SSM's external experts' reviews of  
SKB's safety assessment SR-PSU –  
consequence analysis and hydrogeological aspects  
Main review phase

# Further review of 1BMA and updated 2BMA design – Main review phase

**Activity number:** 3030014-1037  
**Registration number:** SSSM2018-3015  
**Contact person at SSM:** Henrik Öberg

**Figure 3-11. Comparison of Pu-239 fluxes from the 2BMA vault into the geosphere calculated by the AMBER (AMB) and ECOLEGO model (ECL) for the variant cases.**

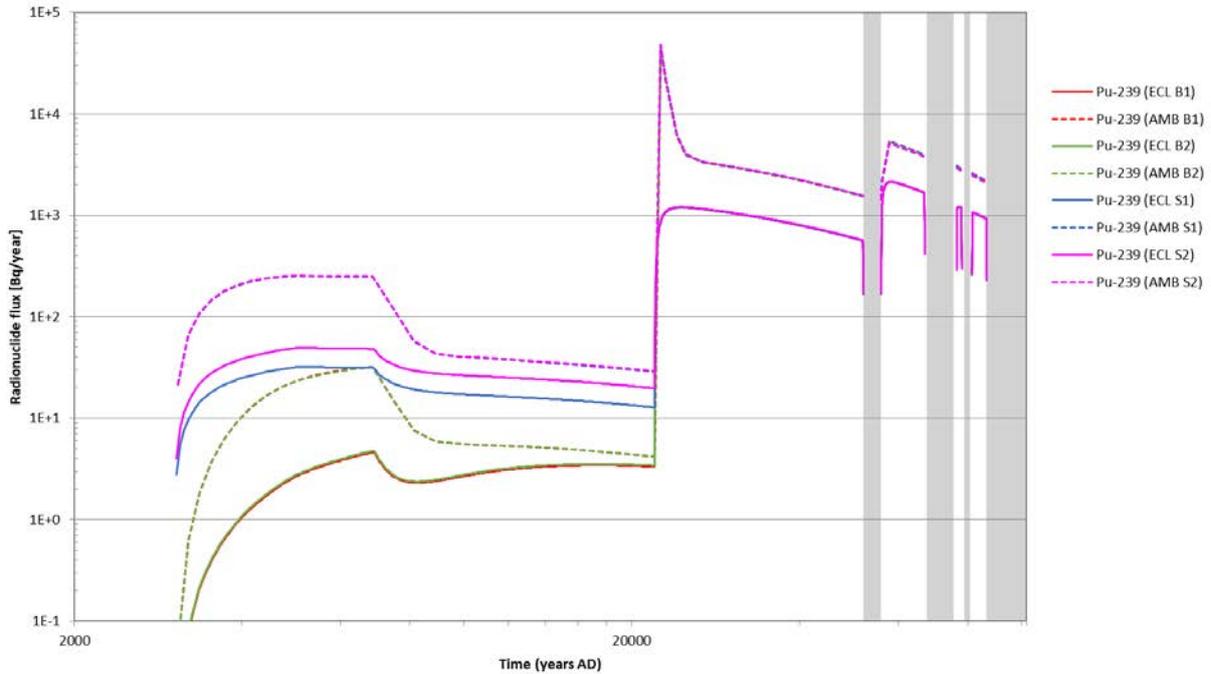
The AMBER and ECOLEGO models show the same relative behaviour between the four variant updated designs of the 2BMA repository. The cases with sand-filled gas channels exhibit higher radionuclide fluxes, particularly when the channels are aligned along the wall perpendicular to the long axis (length) of the vault. This is because the highest flows through the repository are along the length of the vault, so the highest flows will intersect all the channels along this perpendicular wall.

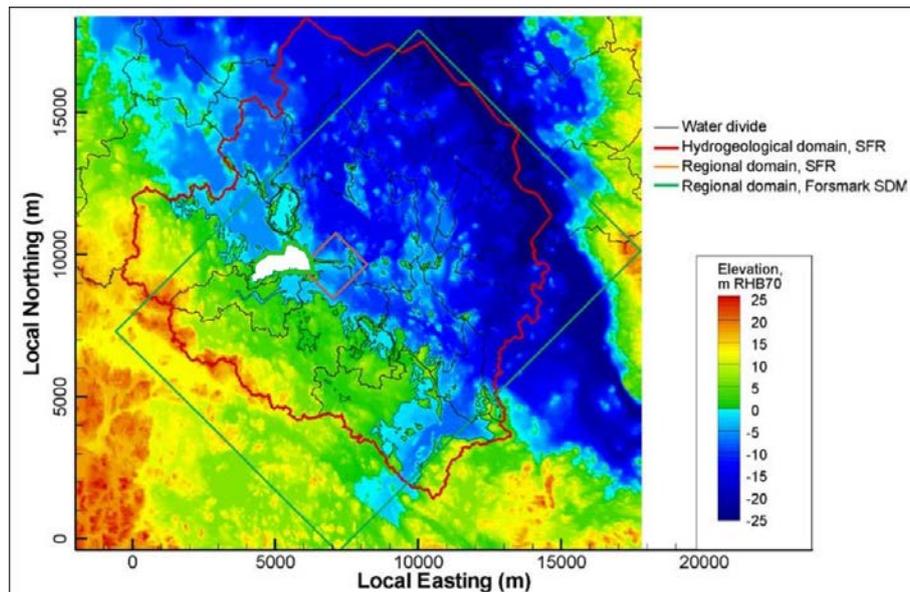
One water management scenario not analysed by SKB is the possibility that the SFR pier and/or other artificial causeways in the area could be utilized and modified as part of a dam for a future water impoundment, either for irrigation or as a hydropower resource. Such an impoundment would cause elevated heads over a broader area for infiltration.

From examination of the topography and bathymetry, a plausible location for such an impoundment near the SFR could be just west side of the facility, as indicated in Figure 9. This would yield a reservoir with a surface area of about  $2 \text{ km}^2$  with depths of 5 m to 10 m, with a need for only a few short sections of berms or dams to connect between existing hillocks and causeways. Such an impoundment would yield approximately a 15 m head difference for small-scale hydropower (either hydroelectric or hydromechanical power utilization), with discharge to nearby lower areas.

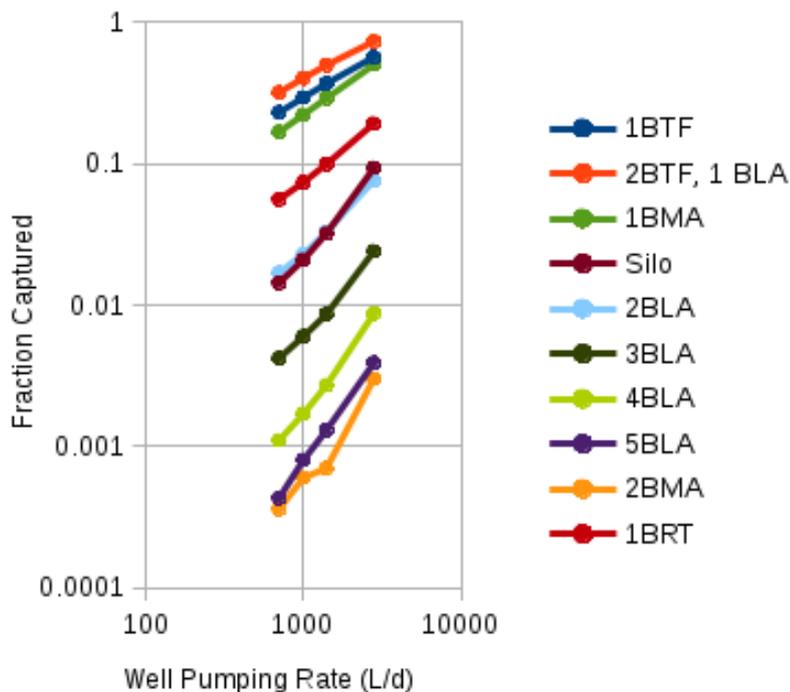
The sensitivity cases with respect to  $Q_{\text{well}}$  (Figure 12) indicate that, contrary to the summary of results by Werner et al. (2013),  $f_v$  could be roughly proportional to  $Q_{\text{well}}^{3/2}$  rather than scaling linearly with  $Q_{\text{well}}$ . This implies that with increasing pumping rates, the radionuclide concentration in the well could increase roughly in proportion to the square root of  $Q_{\text{well}}$  (rather than remaining constant). Thus for a factor of 4 increase in  $Q_{\text{well}}$ , the concentration  $C_m$  could double as a result of enhanced capture.
